ESR Horsley Logistics Park Modification 5

Amendments to Lot 201 warehouse, including installation of plant equipment, amalgamation of tenancies and fit out works

State Significant Development Modification Assessment (SSD-10436-MOD- 5)

February 2022

Figure 6 | Proposed Lot 201 Warehouse

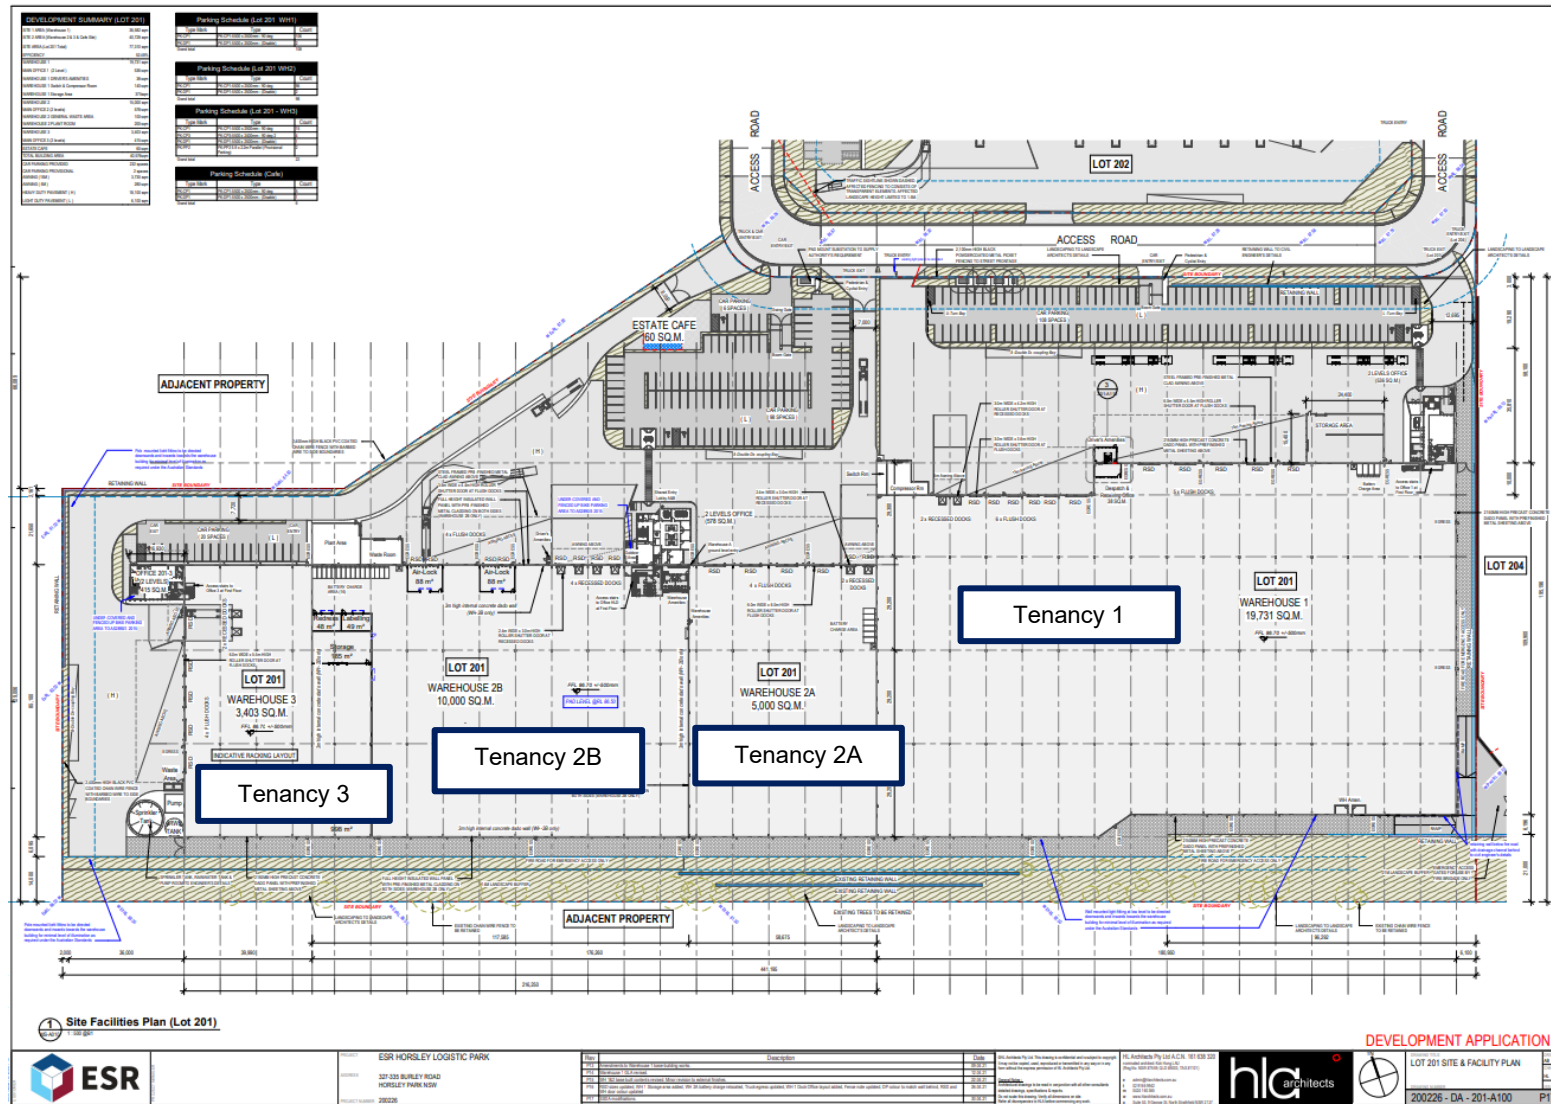
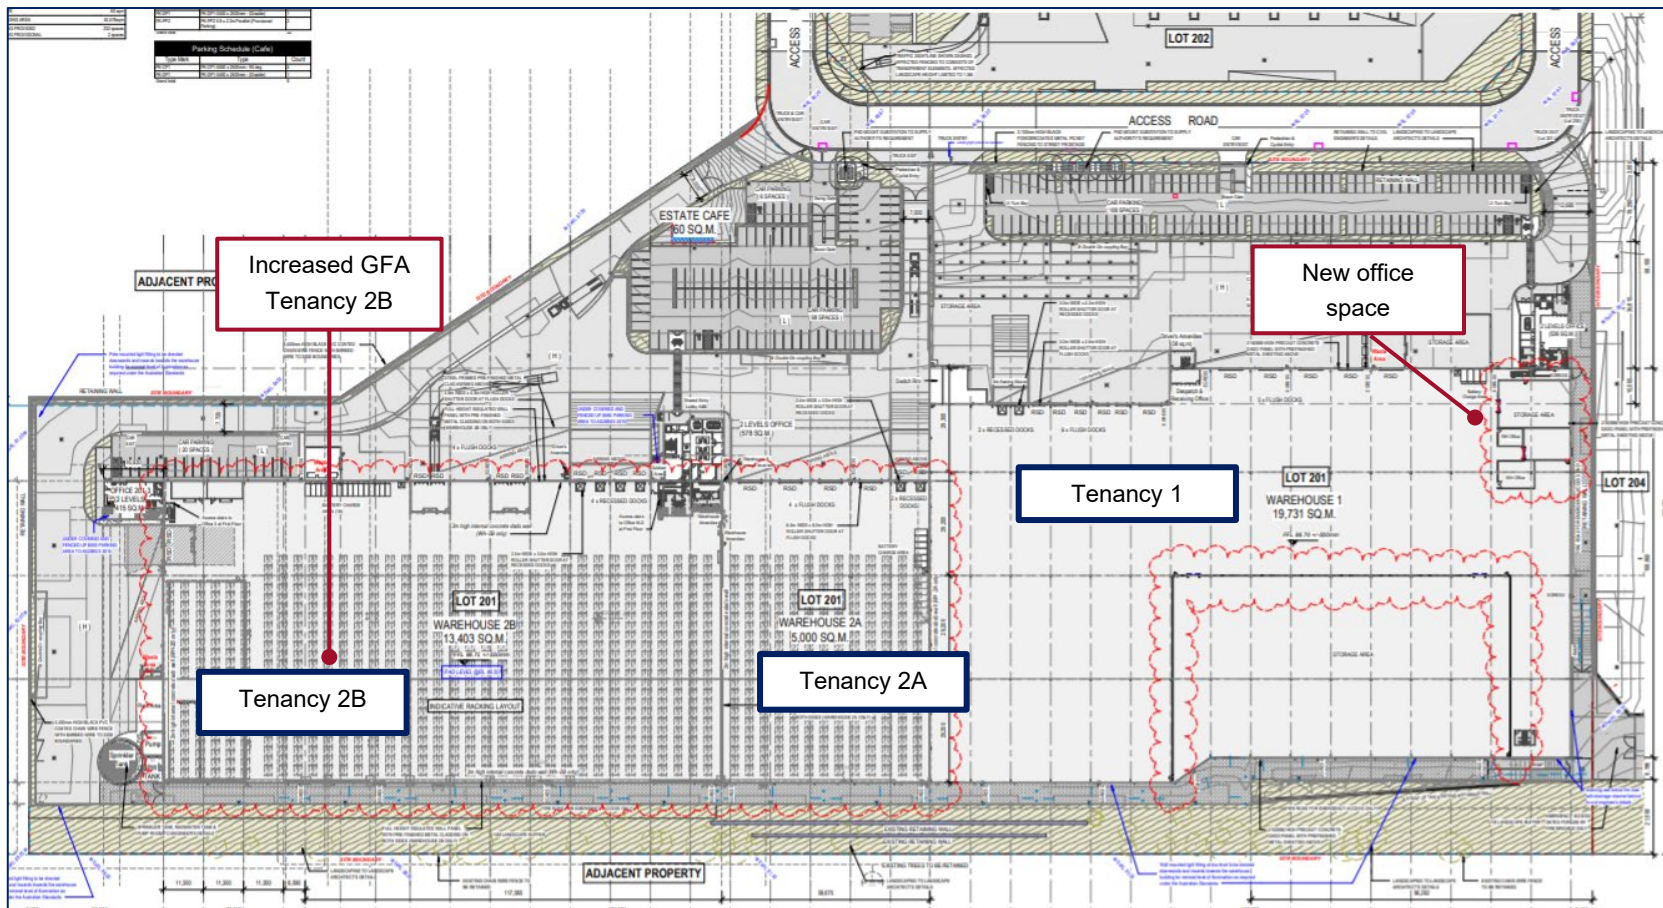
The Applicant lodged a modification application under Section 4.55(1A) of the EP&A Act seeking to amend the Lot 201 warehouse, including installation of 11 temperature cooling units on the roof, fit out of tenancies 2A and 2B and deletion of a roller door, amalgamation of tenancies 2B and 3 and internal works within tenancy 1.

Aspect	Description
Lot 201	
Layout	- Layout changes: - Tenancies 2B and 3 are amalgamated into Tenancy 2B - Relocation of the approved storage area in the amalgamated floor plate - Fit out of tenancy 2A/2B - Internal works within tenancy 1: - New storage area and office areas in the north-eastern section of the tenancy - New storage area and bathroom amenities in the southern section of the tenancy - Removal of roller shutter doors from the western elevation: - Removal of the four flush loading docks and four supporting roller shutter doors
GFA	- Reconfiguration of Tenancy 2 to: - Tenancy 2A: 5,000m² GFA - Tenancy 2B: 13,403 m² GFA - No change is proposed to the overall approved GFA
Rooftop	- Installation of 11 temperature control units on the rooftop of tenancies 2A and 2B operating 24 hours a day, 7 days per week - Each temperature unit is approximately 4.8 m x 2.2 m and 3.5 m high
Maximum Building Height	- SSD-10436-Mod 1 approved height 15 m: no change to existing ridge height (RL 101.70 m) - Additional height of five acoustic barriers and cooling units: RL 106 m (top of screen)
